## PRODUCT/PROCESS CHANGE NOTICE (PCN)

PCN #: **TB1503-01**                      DATE: **July 22, 2015**  
 Product Affected:    **TSSOP-20, TSSOP-24, TSSOP-28,**  
                                  **TSSOP-48, TSSOP-56, TVSOP-48**  
                                  **SOIC-28, SSOP-20, SSOP-28,**  
 (Refer to Attachment II for affected part# shipped in Reel)  
 Date Effective:        **November 2, 2015 Earliest Date - Refer to**  
                                  **specific date by package type**

### ATTACHMENT I - PCN #: TB1503-01

**Detail of Change:** This notification is to advise our customers that IDT has planned to standardize the carrier tape on the selective package types to only one type as detailed below.

#### Illustration of Carrier Tape Pocket Design Change

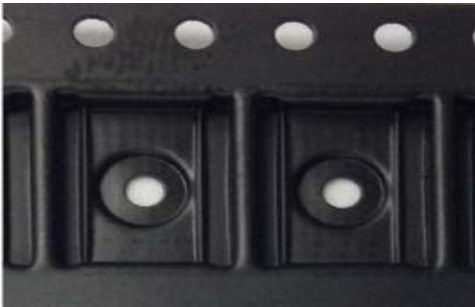
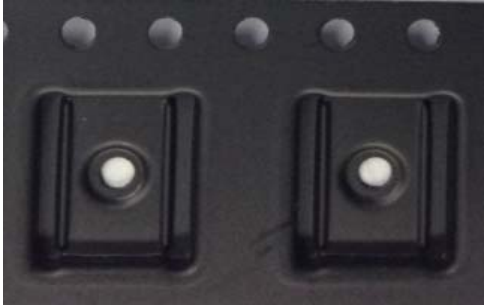
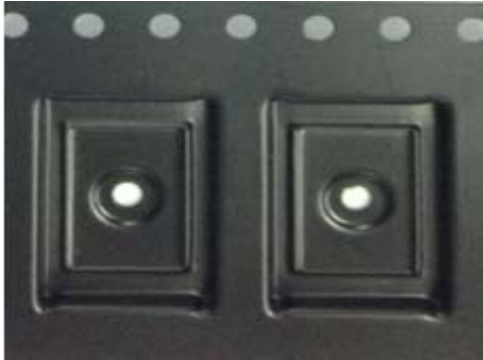
Description	From	To
IDT Carrier Tape Part#	P8-464-000	P8-291-P20
IDT Carrier Tape Drawing#	MSC-7521	MSC-7519
Supplier Carrier Tape Part#	PGG20-20B3-360C-SD	eCA1760-PS-BLK-350
Supplier	PCT	E-PAK
Pocket Width, Ao (mm)	7.15 ± 0.05	7.00 ± 0.10
Pocket Length, Bo (mm)	6.90 ± 0.05	7.00 ± 0.10
Pocket Depth, Ki (mm)	1.25 ± 0.05	1.30 ± 0.10
Pocket Pitch, P1 (mm)	12.0 ± 0.1	8.0 ± 0.1
Total Pocket Depth, Ko (mm)	1.55 ± 0.05	1.60 ± 0.10
Carrier Tape Width, W (mm)	16.0 +0.2/-0.1	16.0 +0.2/-0.1
Carrier Tape Thickness, T (mm)	0.30 ± 0.05	0.30 ± 0.05

Description	From	To
IDT Carrier Tape Part#	P8-329-P24	P8-169-P24
IDT Carrier Tape Drawing#	MSC-5914	MSC-3388
Supplier Carrier Tape Part#	TSSOP24L-20B3-360C-SD	TSS30P12GP-20B3-360-SD
Supplier	PCT	PCT
Pocket Width, Ao (mm)	6.85 ± 0.10	7.00 ± 0.10
Pocket Length, Bo (mm)	8.20 ± 0.10	8.20 ± 0.10
Pocket Depth, Ki (mm)	1.40 ± 0.10	1.30 ± 0.10
Pocket Pitch, P1 (mm)	8.00 ± 0.10	12.00 ± 0.10
Total Pocket Depth, Ko (mm)	1.70 ± 0.10	1.55 ± 0.10
Carrier Tape Width, W (mm)	16.0 +0.2/-0.1	16.0 +0.2/-0.1
Carrier Tape Thickness, T (mm)	0.30 ± 0.05	0.30 ± 0.05

Description	From	To
IDT Carrier Tape Part#	P8-260-P48	P8-324-P48
IDT Carrier Tape Drawing#	MSC-7388	MSC-7539
Supplier Carrier Tape Part#	TSS48P16GP-22B3-360C-SD	eCA1765-PS-BLK-350
Supplier	PCT	E-PAK
Pocket Width, Ao (mm)	8.45 ± 0.13	8.85 ± 0.10
Pocket Length, Bo (mm)	13.00 ± 0.13	12.90 ± 0.10
Pocket Depth, Ki (mm)	1.20 ± 0.10	1.30 ± 0.10
Pocket Pitch, P1 (mm)	16.00 ± 0.10	12.00 ± 0.10
Total Pocket Depth, Ko (mm)	1.60 ± 0.10	1.50 ± 0.10
Carrier Tape Width, W (mm)	24.0 +0.2/-0.1	24.0 +0.2/-0.1
Carrier Tape Thickness, T (mm)	0.30 ± 0.05	0.30 ± 0.05

Package	From	To
TSSOP-20	Carrier Tape Part# P8-464-000 	Carrier Tape Part# P8-291-P20 
TSSOP-24	Carrier Tape Part# P8-329-P24 	Carrier Tape Part# P8-169-P24 
TSSOP-48	Carrier Tape Part# P8-260-P48 	Carrier Tape Part# P8-324-P48

#### Illustration of Carrier Tape Pocket Design Change

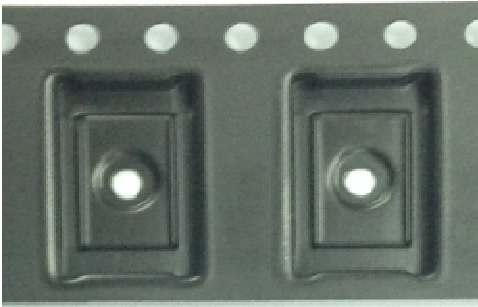
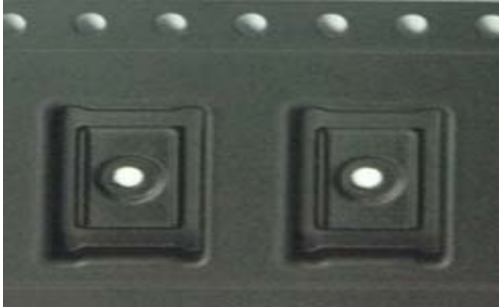
Description	From	To
IDT Carrier Tape Part#	P8-187-S28	P8-370-P28
IDT Carrier Tape Drawing#	MSC-3405	MSC-5938
Supplier Carrier Tape Part#	SO28NP-22B3-75C-SD	SO28W32-22B3-62C-SD
Supplier	PCT	PCT
Pocket Width, Ao (mm)	10.80 ± 0.10	10.90 ± 0.10
Pocket Length, Bo (mm)	18.55 ± 0.10	18.55 ± 0.10
Pocket Depth, Ki (mm)	2.60 ± 0.10	2.70 ± 0.10
Pocket Pitch, P1 (mm)	12.00 ± 0.10	16.00 ± 0.10
Total Pocket Depth, Ko (mm)	3.00 ± 0.10	3.10 ± 0.10
Carrier Tape Width, W (mm)	24.0 ± 0.3	32.0 ± 0.3
Carrier Tape Thickness, T (mm)	0.30 ± 0.05	0.30 ± 0.05

Description	From	To
IDT Carrier Tape Part#	P8-145-PF8	P8-330-P48
IDT Carrier Tape Drawing#	MSC-3196	MSC-5915
Supplier Carrier Tape Part#	TSS28/38GP-22B3-120-SD	TSSOP48LGP-22B7-120C-SD
Supplier	PCT	PCT
Pocket Width, Ao (mm)	6.90 ± 0.13	7.10 ± 0.10
Pocket Length, Bo (mm)	10.10 ± 0.13	10.10 ± 0.10
Pocket Depth, Ki (mm)	1.30 ± 0.10	1.30 ± 0.10
Pocket Pitch, P1 (mm)	12.00 ± 0.10	12.00 ± 0.10
Total Pocket Depth, Ko (mm)	1.50 ± 0.10	1.50 ± 0.10
Carrier Tape Width, W (mm)	16.00 ± 0.30	24.0 +0.2/-0.1
Carrier Tape Thickness, T (mm)	0.30 ± 0.05	0.30 ± 0.05

Description	From	To
IDT Carrier Tape Part#	P8-261-P56	P8-314-P56
IDT Carrier Tape Drawing#	MSC-7398	MSC-7543
Supplier Carrier Tape Part#	PA56SGP-22B3-360C-SD	eCA1764-PS-BLK-350
Supplier	PCT	E-PAK
Pocket Width, Ao (mm)	8.45 ± 0.13	8.85 ± 0.10
Pocket Length, Bo (mm)	14.50 ± 0.13	14.60 ± 0.10
Pocket Depth, Ki (mm)	1.20 ± 0.13	1.30 ± 0.10
Pocket Pitch, P1 (mm)	16.00 ± 0.10	12.00 ± 0.10
Total Pocket Depth, Ko (mm)	1.60 ± 0.13	1.50 ± 0.10
Carrier Tape Width, W (mm)	24.0 ± 0.3	24.0 +0.2/-0.1
Carrier Tape Thickness, T (mm)	0.30 ± 0.05	0.30 ± 0.05

Package	From	To
SOIC-28	Carrier Tape Part# P8-187-S28 	Carrier Tape Part# P8-370-P28 
TSSOP-28 and TVSOP- 48	Carrier Tape Part# P8-145-PF8 	Carrier Tape Part# P8-330-P48 
TSSOP-56	Carrier Tape Part# P8-261-P56 	Carrier Tape Part# P8-314-P56

#### Illustration of Carrier Tape Pocket Design Change

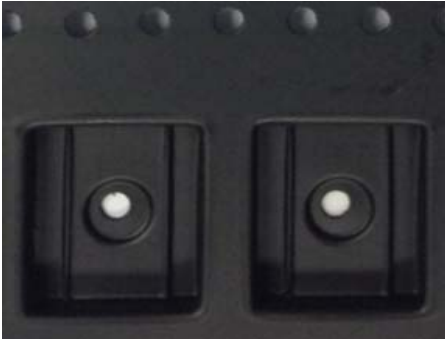
Description	From	To
IDT Carrier Tape Part#	P8-259-P20	P8-320-P20
IDT Carrier Tape Drawing#	MSC-7395	MSC-5909
Supplier Carrier Tape Part#	SSOP20SGP-22B3-360C-SD	SSOP20GP-22B3-80C-SD
Supplier	PCT	PCT
Pocket Width, Ao (mm)	8.20 ± 0.10	8.60 ± 0.10
Pocket Length, Bo (mm)	7.50 ± 0.10	7.60 ± 0.10
Pocket Depth, Ki (mm)	2.10 ± 0.10	2.00 ± 0.10
Pocket Pitch, P1 (mm)	12.00 ± 0.10	12.00 ± 0.10
Total Pocket Depth, Ko (mm)	2.50 ± 0.10	2.30 ± 0.10
Carrier Tape Width, W (mm)	16.0 ± 0.3	16.0 ± 0.3
Carrier Tape Thickness, T (mm)	0.30 ± 0.05	0.30 ± 0.05

Description	From	To
IDT Carrier Tape Part#	P8-384-P28	P8-321-P28
IDT Carrier Tape Drawing#	MSC-7356	MSC-5910
Supplier Carrier Tape Part#	EIAJ14GP-22B3-75C-SD	SSOP28W24PGP-22B3-180C-SD
Supplier	PCT	PCT
Pocket Width, Ao (mm)	8.40 ± 0.10	8.90 ± 0.10
Pocket Length, Bo (mm)	10.70 ± 0.10	10.60 ± 0.10
Pocket Depth, Ki (mm)	2.10 ± 0.10	2.00 ± 0.10
Pocket Pitch, P1 (mm)	12.00 ± 0.10	12.00 ± 0.10
Total Pocket Depth, Ko (mm)	2.40 ± 0.10	2.30 ± 0.10
Carrier Tape Width, W (mm)	16.0 ± 0.3	24.0 ± 0.3
Carrier Tape Thickness, T (mm)	0.30 ± 0.05	0.30 ± 0.05

Package	From	To
SSOP-20	Carrier Tape Part# P8-259-P20 	Carrier Tape Part# P8-320-P20 
SSOP-28	Carrier Tape Part# P8-384-P28 	Carrier Tape Part# P8-321-P28
